Resilience Research Center

City of Madison
Land Use Application Submittal
Resilience Research Center

8 September 2010 / Revised 22 October 2010

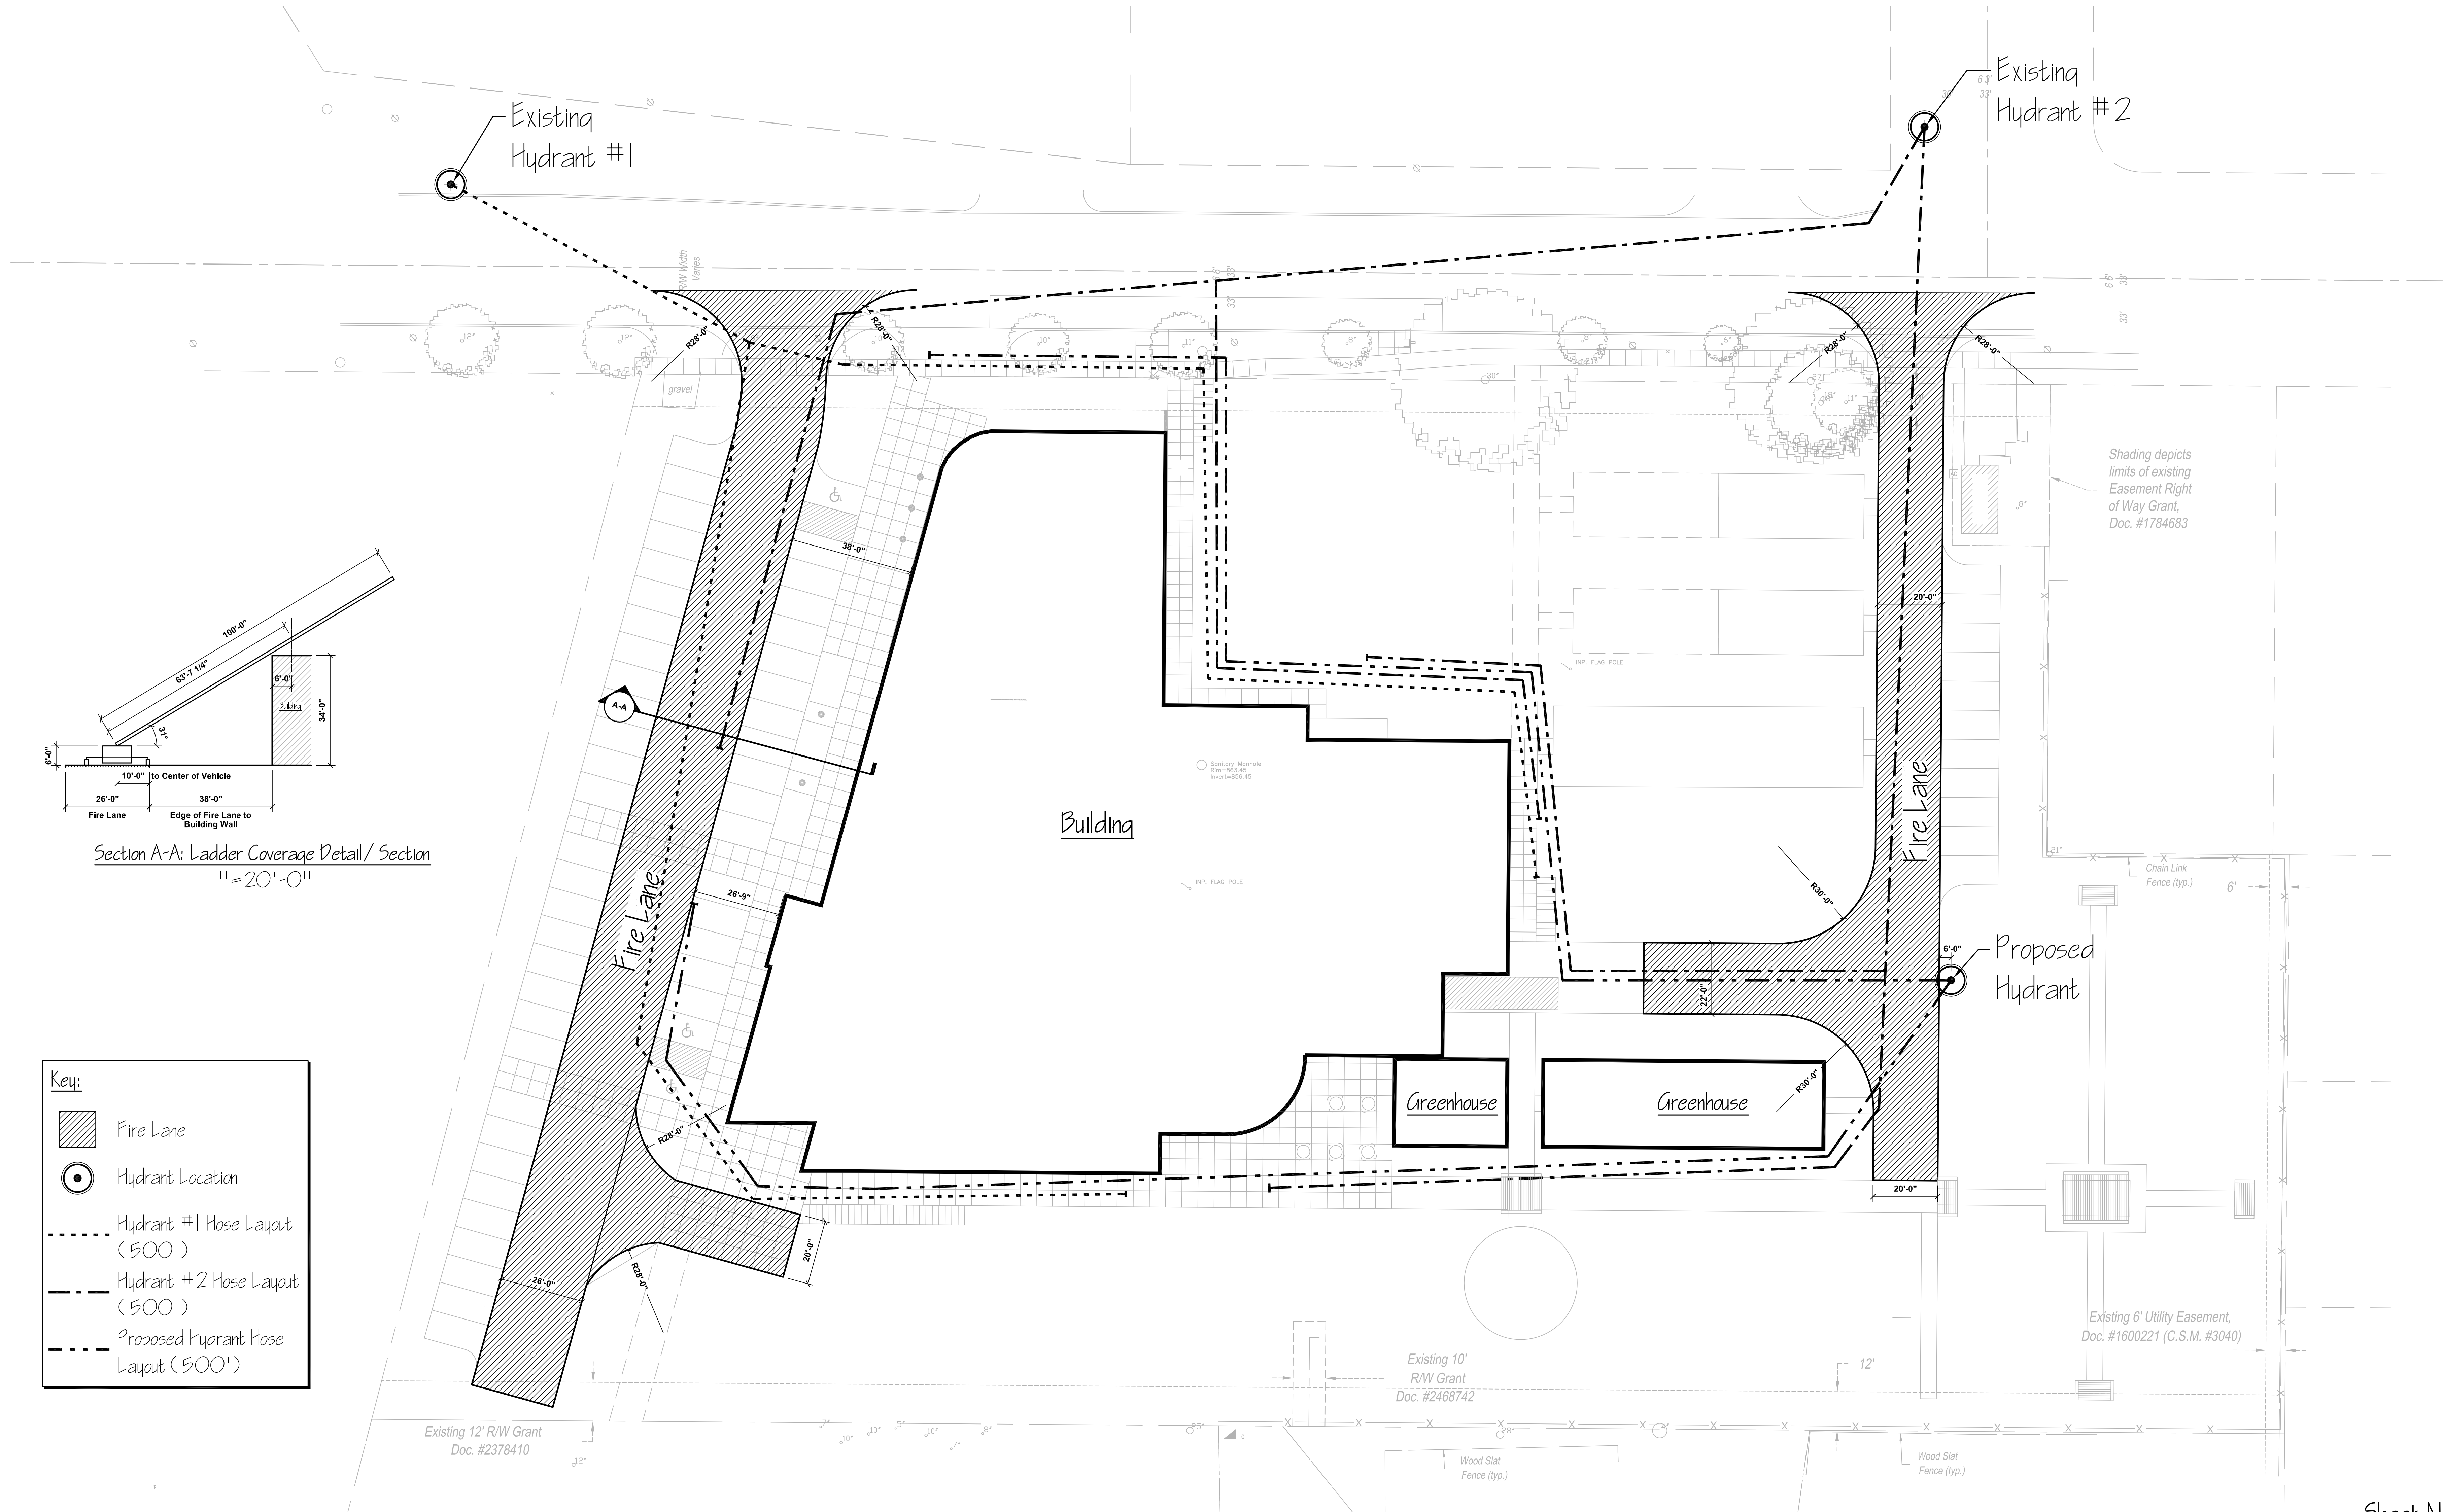
- REVISED 10-22-10:**
- UPDATE BUILDING ENVELOPE & FLOOR PLAN.
 - REVISE GARDEN STRUCTURE NOTES.
 - ADD RIBBON CURB & GRASSCRETE TO PARKING AREAS

Utility Plan

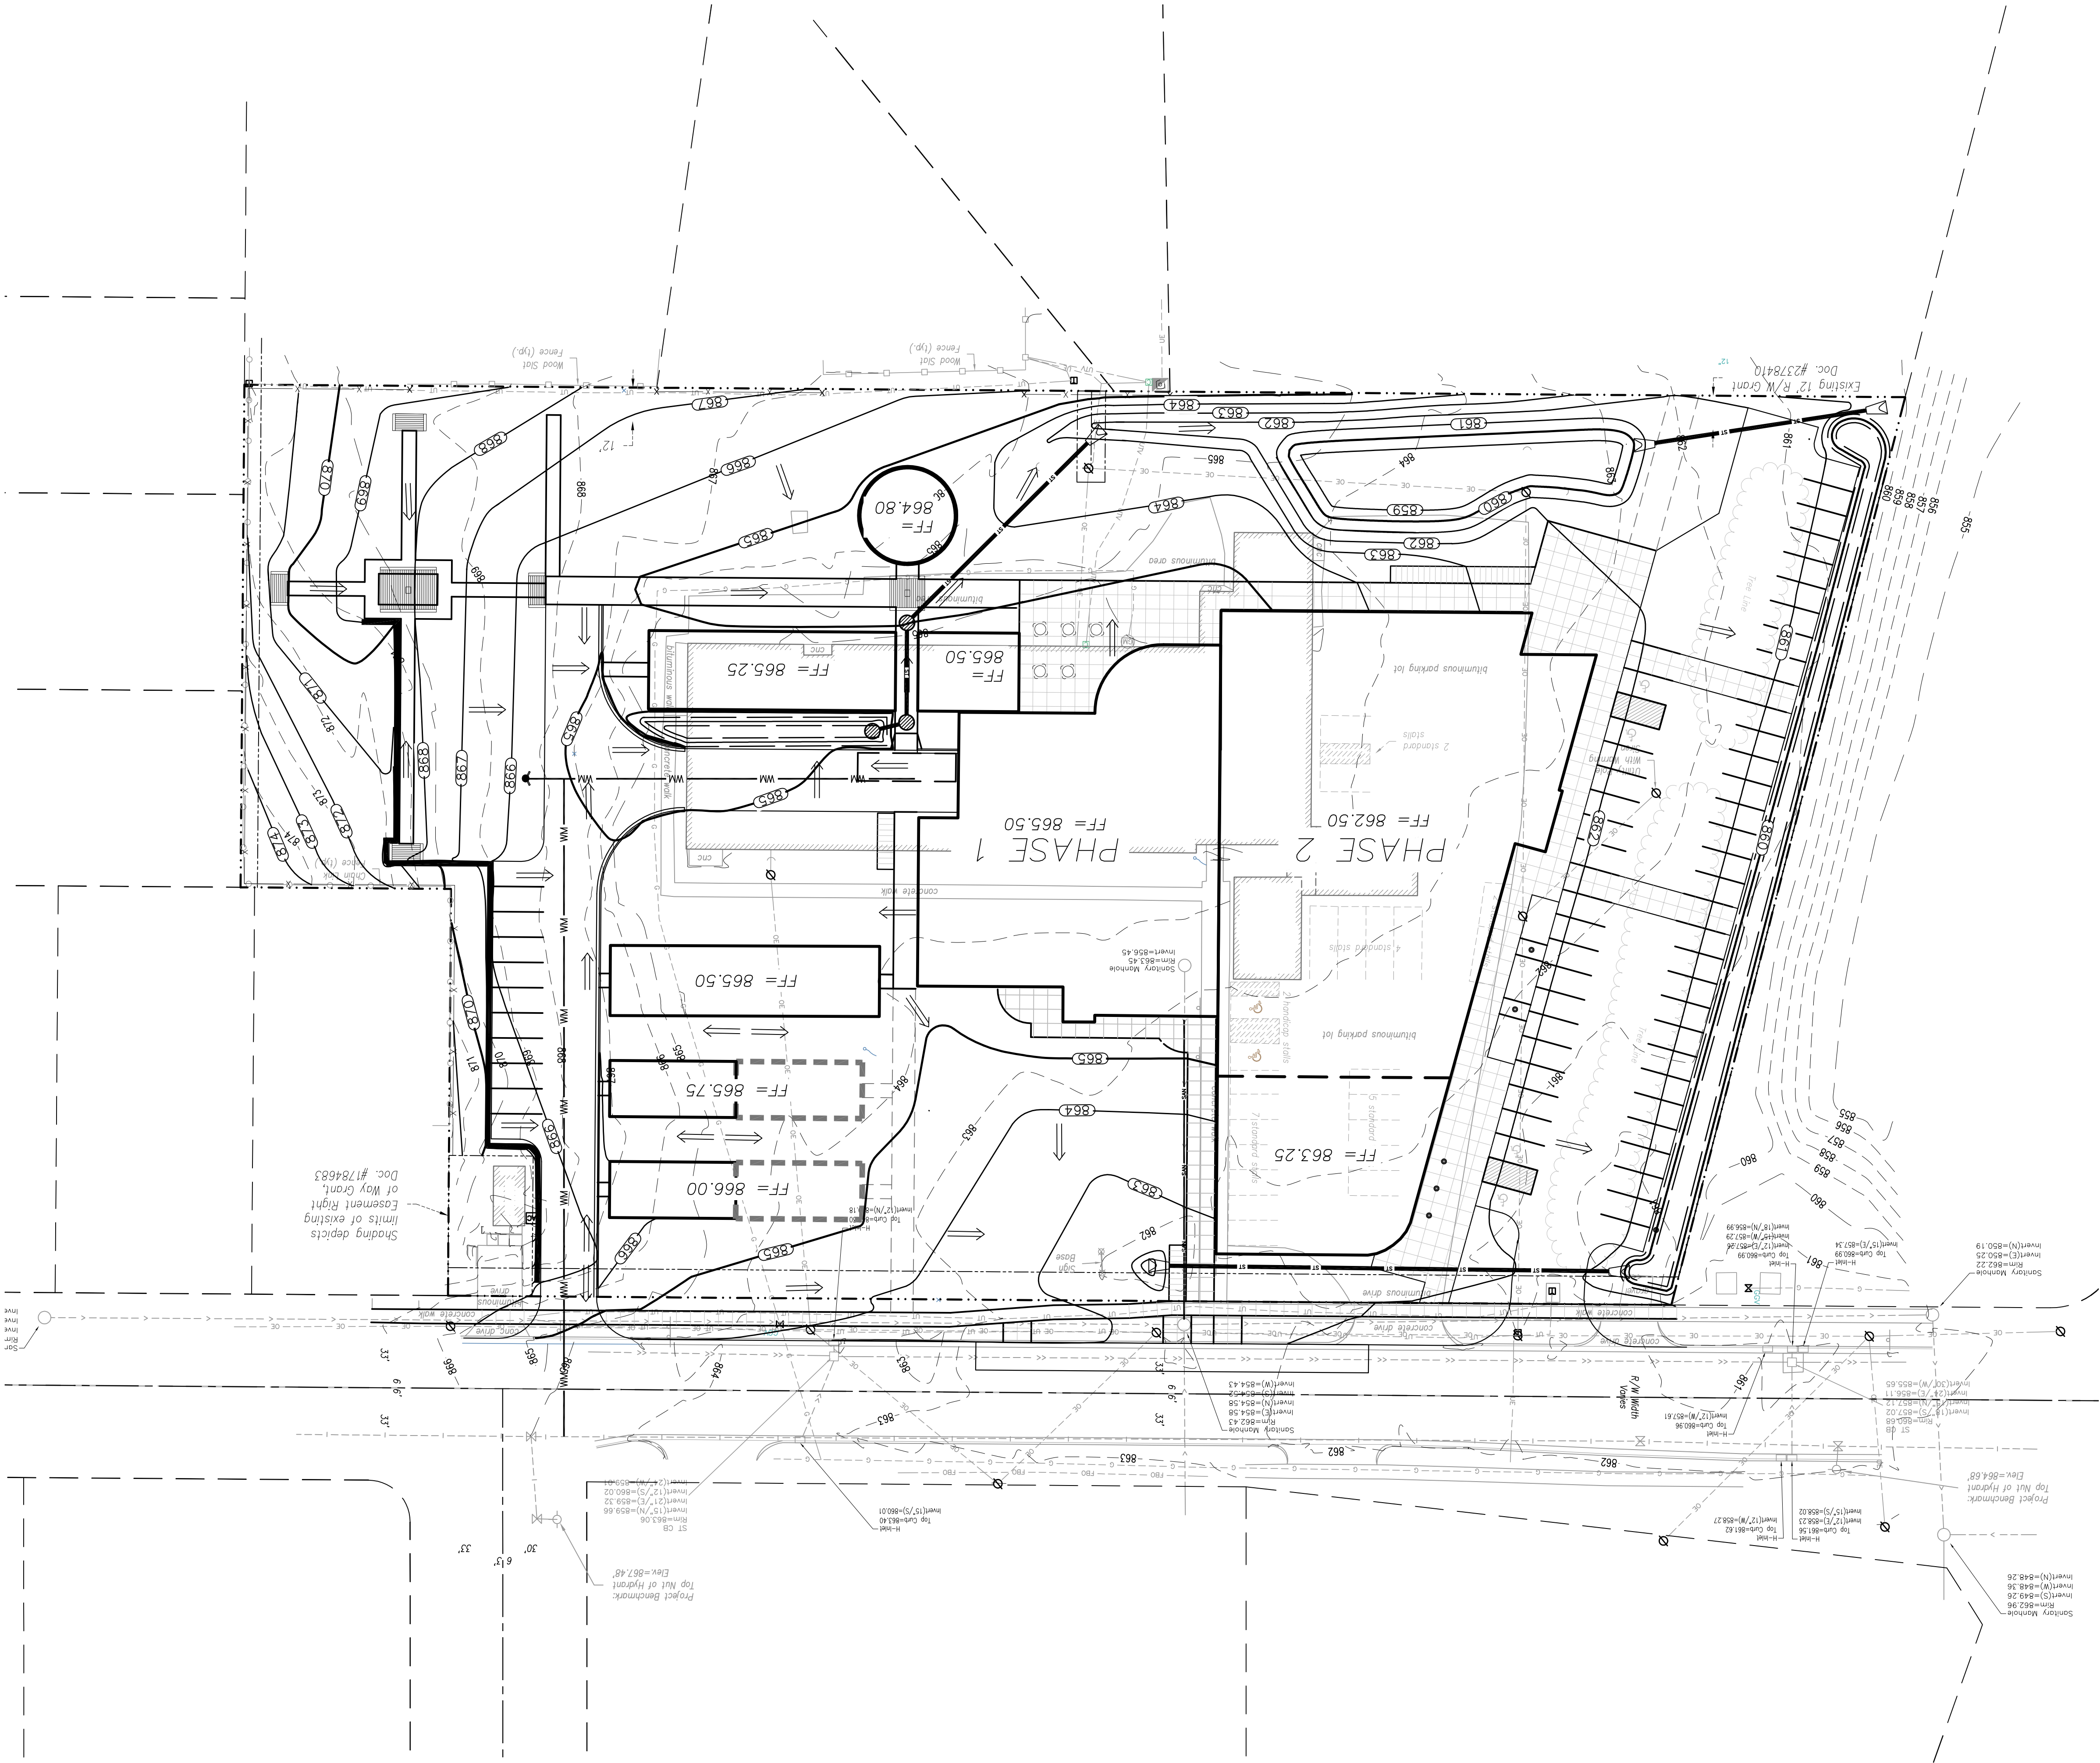
REVISED 10-22-10:

- REMOVED GRADING CONTOURS AND SPOT ELEVATIONS
- REMOVED BIOFILTRATION BASINS

Sheet No. 10.0
 Floor Plans
 Resilience Research Center

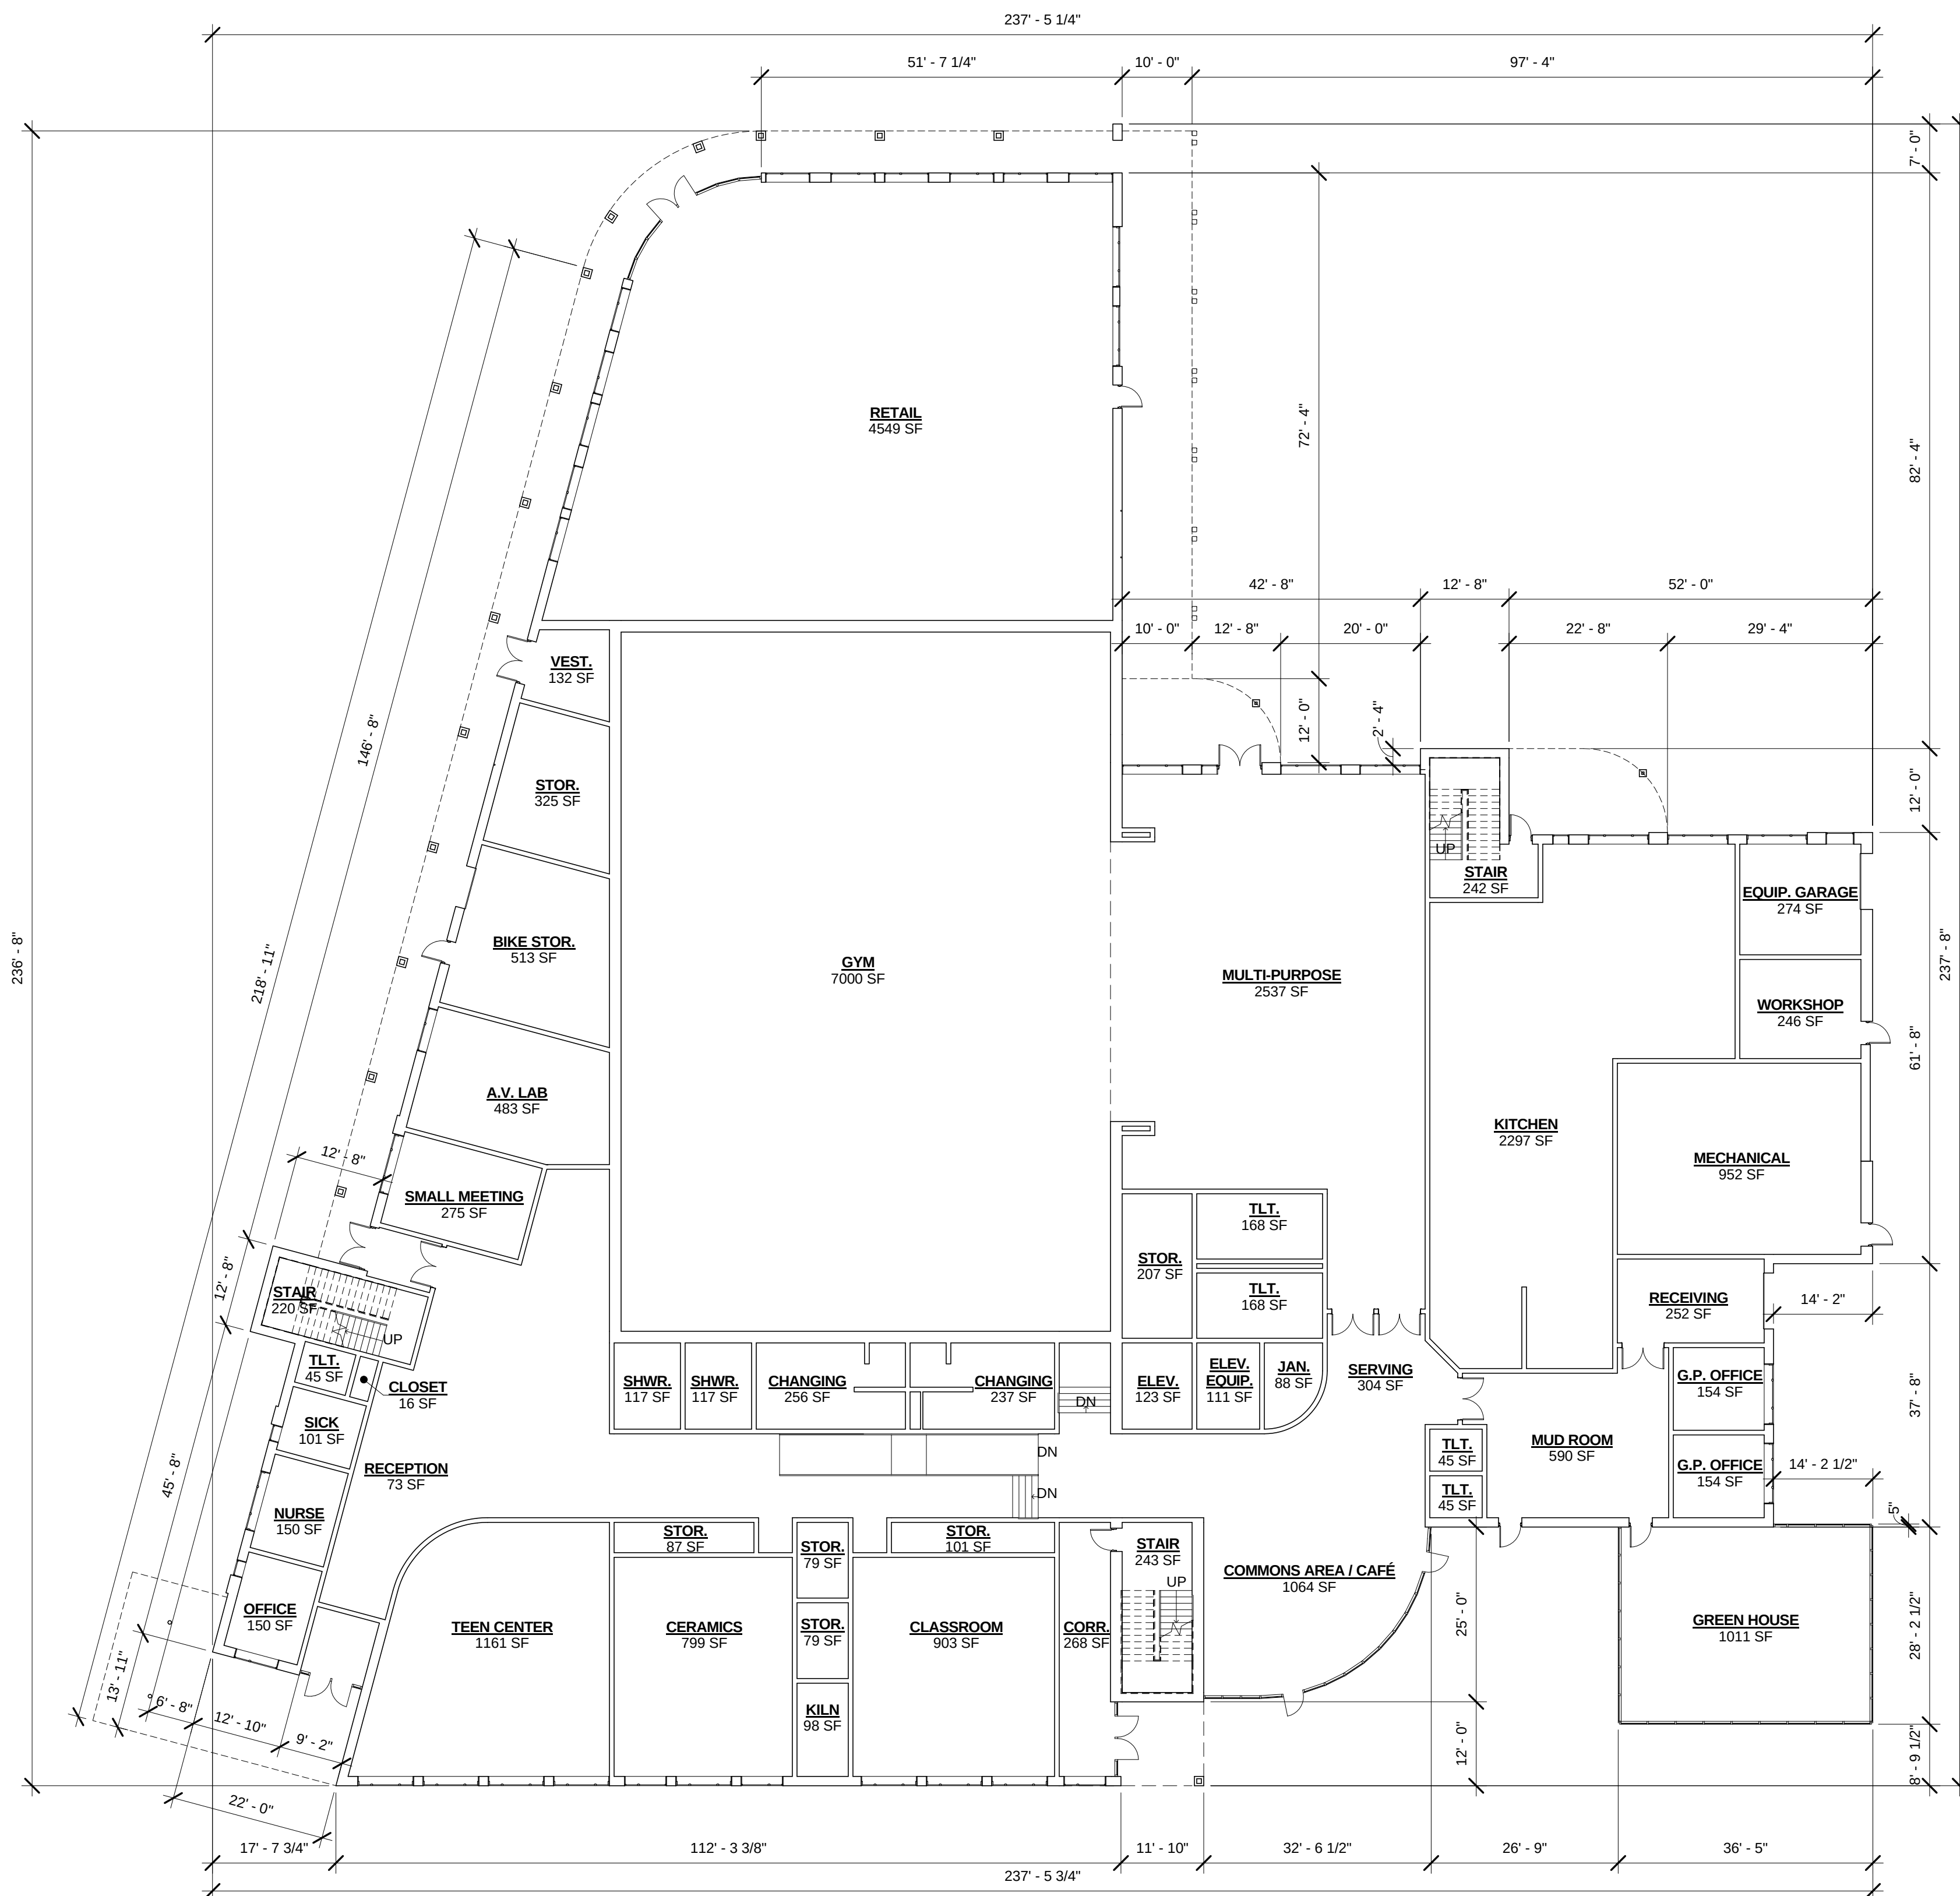
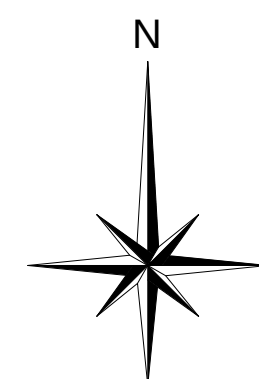
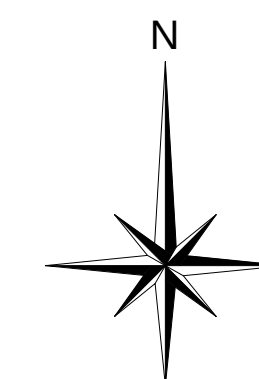
REVISED 10-22-10:

- ALTERED STAIR ORIENTATION / LOCATIONS.
- MODIFIED MAIN ENTRANCE
- UPDATED PLAN AT OFFICES, LEARNING STUDIOS AND MECHANICAL AREAS
